Section 6

ADMINISTRATIVE CONTROLS

6.3-2
Proposed Change No. 7
October 8, 1971

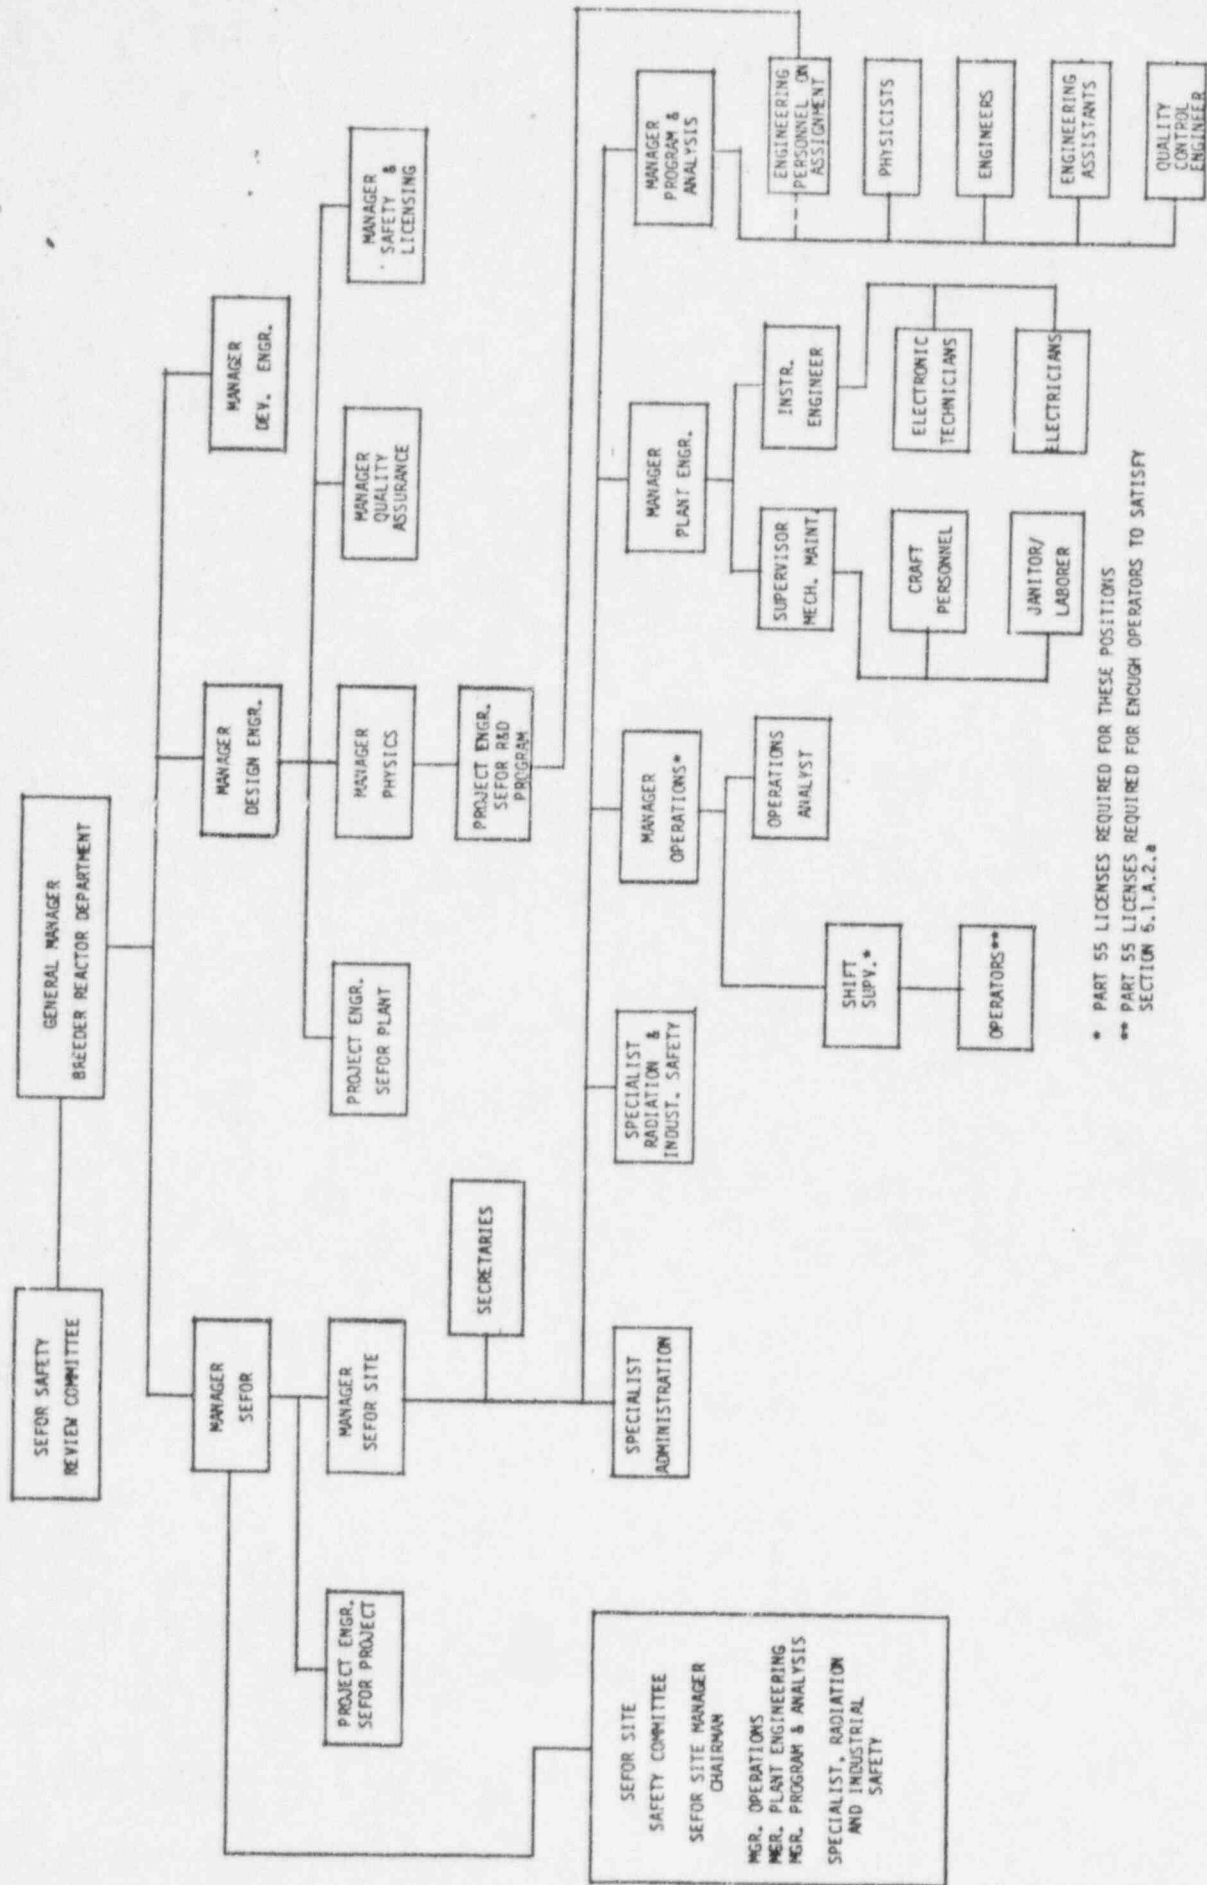
1. The organization for management, operation, and audit of SEFOR facility operations shall be as given in Figure 6-1. The overall full-time responsibility for operation of the SEFOR facility and compliance with these Technical Specifications shall reside in the SEFOR Facility Site Manager. The Site Manager reports to the Manager, SEFOR, who in turn is responsible directly to the BRDØ General Manager. The BRDØ General Manager reports to the Nuclear Energy Division General Manager. As indicated in Figure 6-1, technical engineering assistance will be provided as necessary through the BRDØ Manager of ~~Plant Engineering and Projects~~ Design Engineering.

- d. Personnel requiring Part 55 licenses shall be as indicated in Figure 6-1.
3. Qualifications with regard to education and operating experience for key supervisory personnel shall be as follows:
